**December 3, 2015**  
**Willowmoor Floodplain Restoration Project**  
**DRAFT Alternatives Considerations Memo**

**WILLOWMOOR FLOODPLAIN RESTORATION PROJECT****STAKEHOLDER ADVISORY COMMITTEE****Meeting #9: October 14, 2015****--Meeting Report--****SAC Members Present:**

**Figure 1: Design considerations communicated to project team at SAC meeting #8, 12/10/2014. Many of these items will be resolved as the project moves from conceptual to 30% design.**

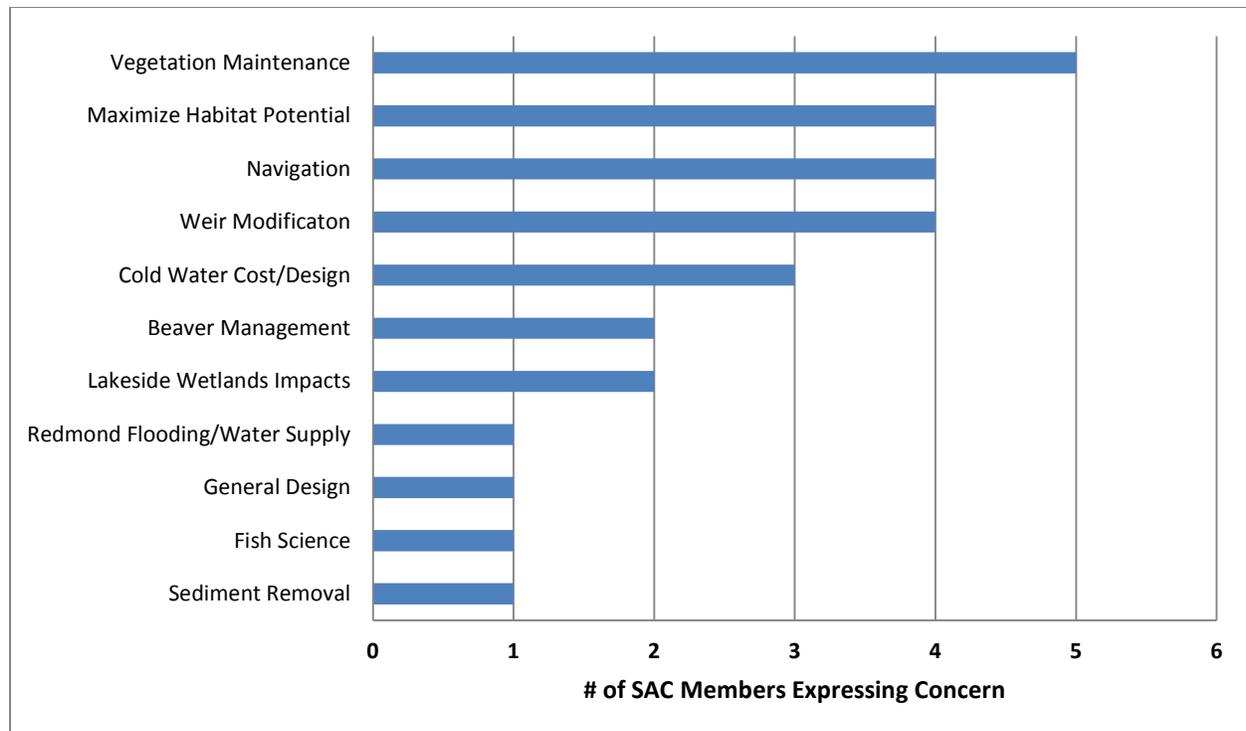
At the second to last SAC meeting (#8) the two conceptual design alternatives were presented to SAC members along with the Existing Maintenance alternative. The presentation included plans, sections, and 3-dimensional graphics for each alternative as well as detailed information about estimated costs, benefits and concerns. SAC members were asked at the meeting to verbally weigh in on what they liked and disliked most about each alternative. Most declined to state a solid preference as they wanted time to review the materials and discuss with their constituencies. While there was no clear “winner” among the alternatives, each one had some supporters. However, the Split Channels with Pumped Ground Water received the most positive comments. Members found this alternative intriguing because it appeared to have the most benefits for flood control, high lake level reduction and habitat enhancements. However, there were many questions remaining that will require resolution in later design stages. For example, some members were concerned that there would not be enough vegetation maintenance, while others were afraid that it would go too far, leaving an unshaded, warmer channel than is on the site currently (Figure 1).

As noted above, more detail was requested for habitat elements, navigation features and weir modification designs. Some SAC members were also very concerned about the costs of the habitat elements of the project and the feasibility of funding them, particularly something as unconventional as cold water supplementation. A representative from WRIA 8 indicated that the magnitude of the costs were very much in line with typical salmon recovery project costs. Determining attractiveness of the cold water approach was something however that could be vetted through grant applications.

The project team indicated that answers to several of the questions could be found in the Conceptual Design Report, and asked SAC members to review the report and comment in writing at a later time by mail, email, through a survey online, or through a survey that would be provided at the subsequent public meeting. Members were also asked share the conceptual design report with their constituencies and invite them to the public meeting to provide input.
